|||||LINCOLN ROAD DISTRICT

**HISTORIC PRESERVATION BOARD
REVISED APPLICATION**

05/14/2024

LINCOLN ROAD DISTRICT IMPROVEMENTS PHASE 3

COLOR PALETTE - OPT 5 - 1/2" BY 1/2" CERAMIC

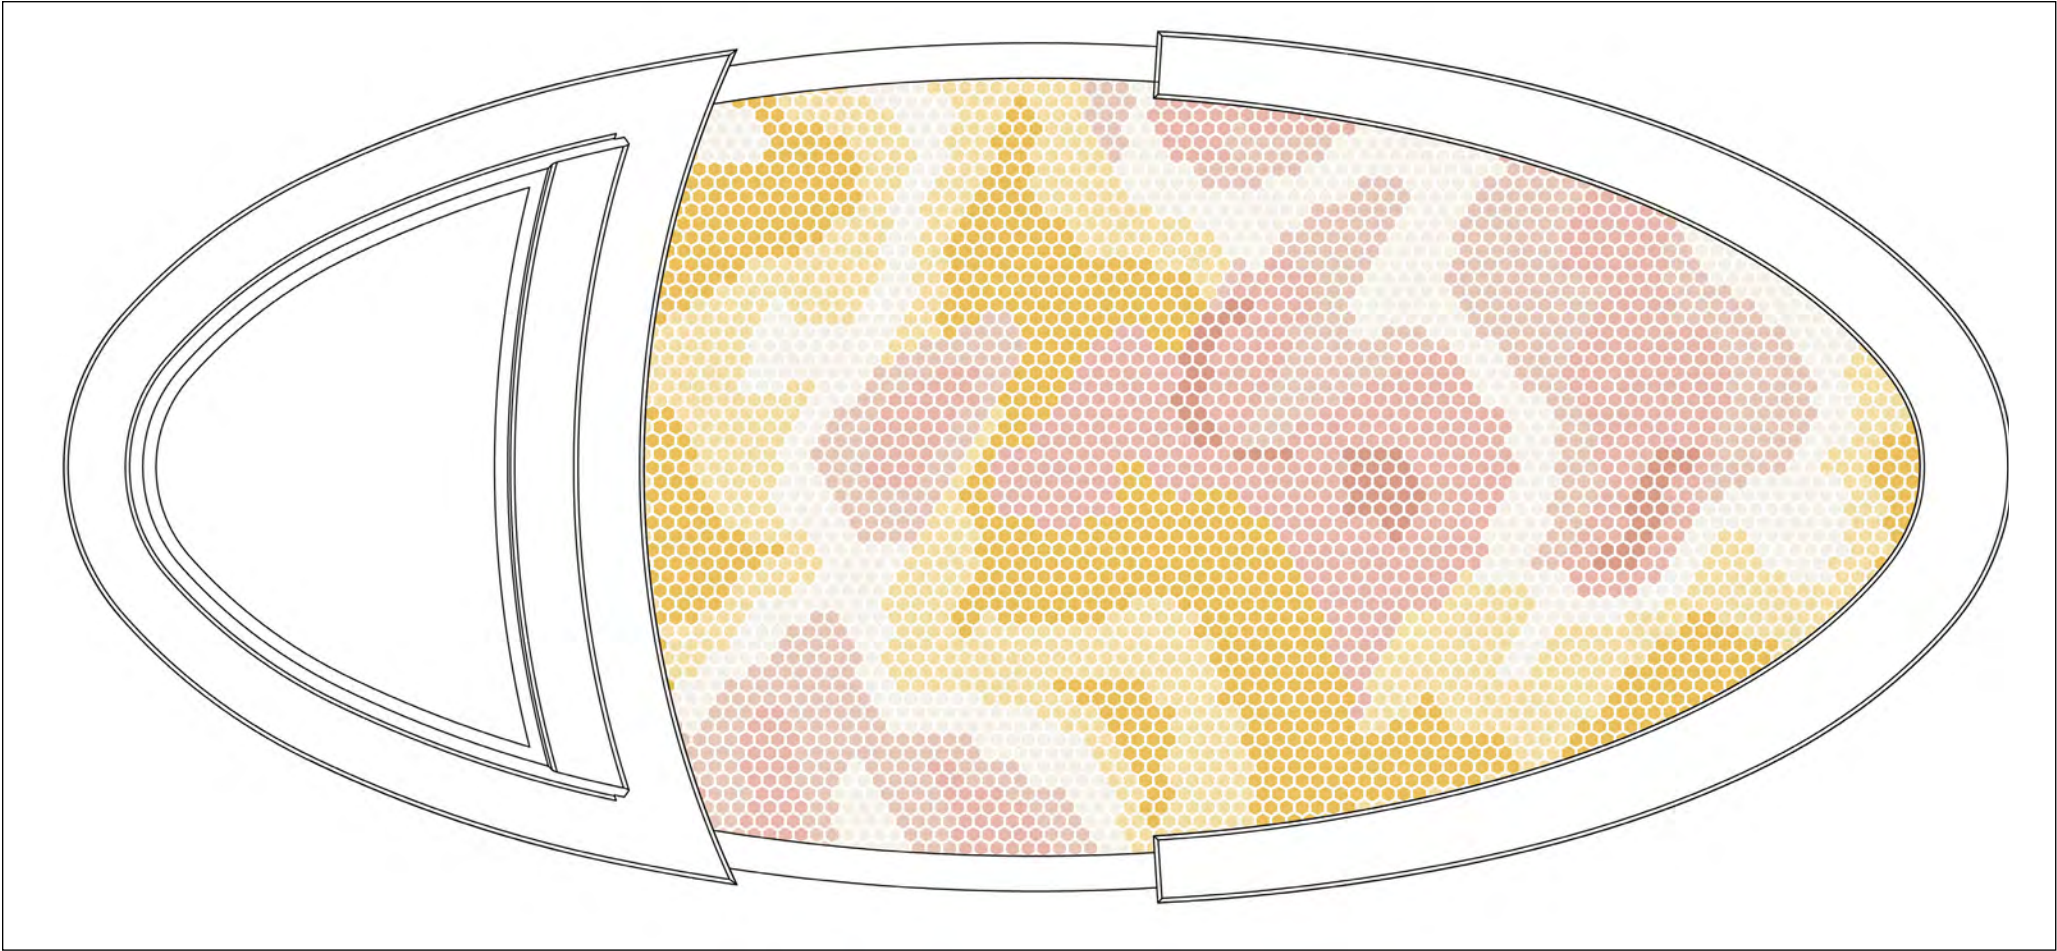
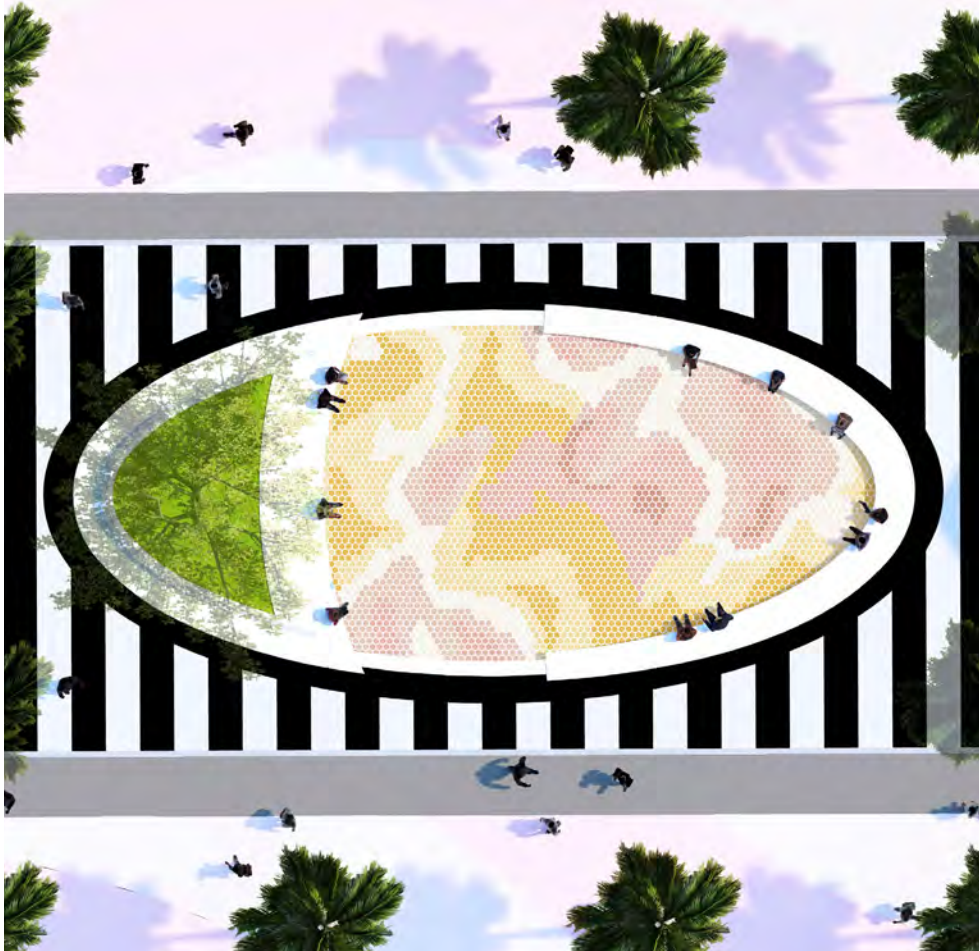
PAVING- CONSIDER OTHER MATERIAL ALTERNATIVES TO PROPOSED CERAMIC TILE

EUCLID OVAL PAVING
OPTION 2- 8" HEXAGONAL PRECAST CONCRETE PAVERS (05/14/2024)

EUCLID OVAL PAVING
OPTION 3- 8" PRECAST CONCRETE HEX PAVER (05/14/2024)

OPTION 4- 1/2" X 1/2" CERAMIC MOSAIC (05/14/2024)

EUCLID OVAL PAVING
OPTION 5- 1/2" X 1/2" CERAMIC MOSAIC (05/14/2024)

LINCOLN ROAD WAYFINDING SIGNAGE
REVISED DESIGNS 05/14/2024

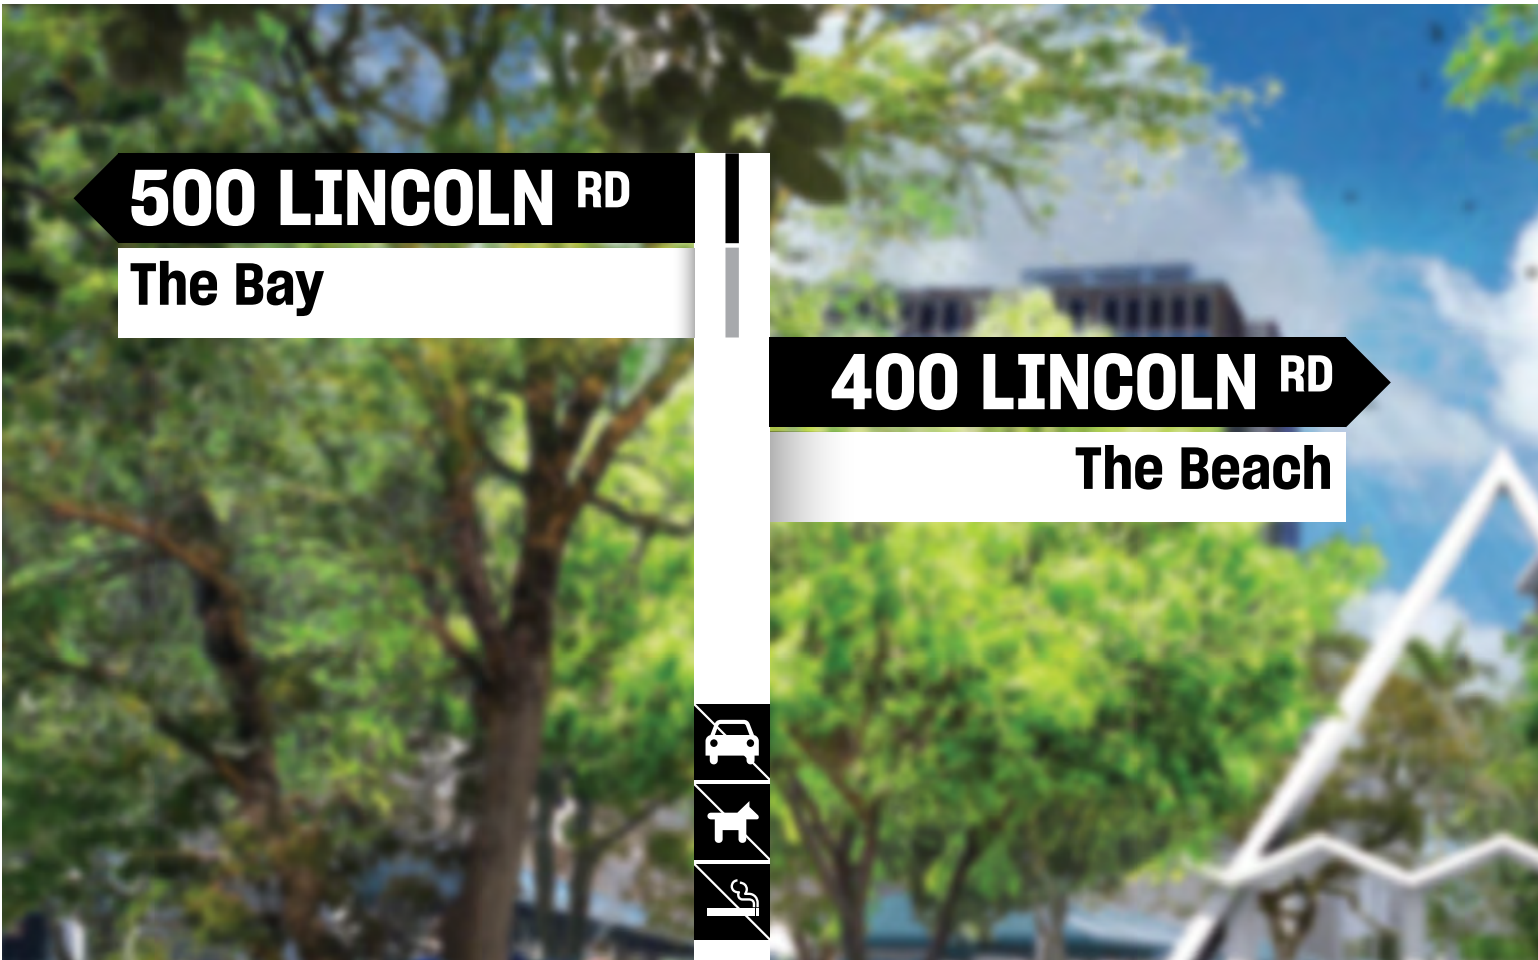
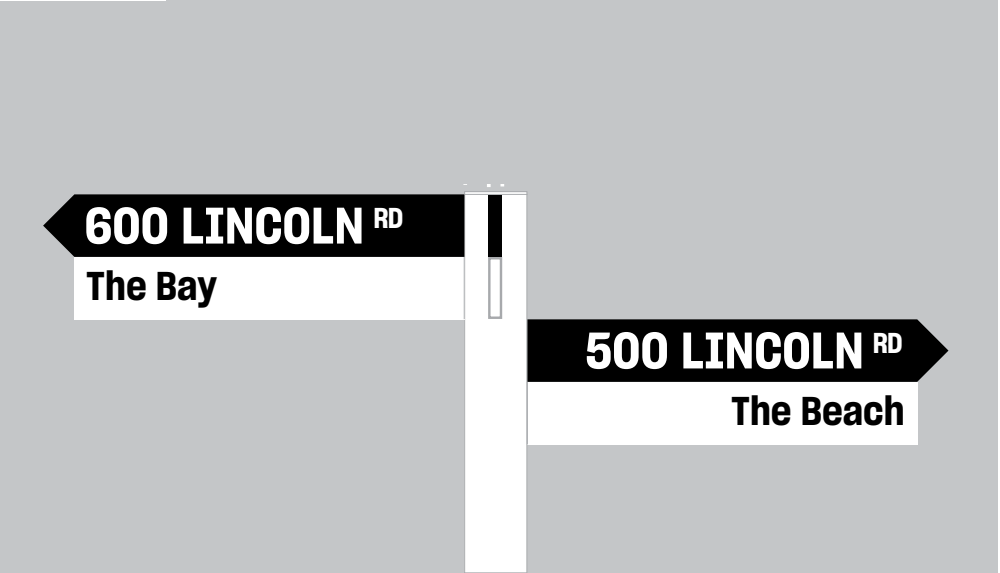
CLARIFY DESTINATION SIGNAGE INTENT

SIMPLIFY SIGNAGE

PREVIOUS DESIGNS (02/13/2024)

PROPOSED REVISED DESIGNS (05/14/2024)
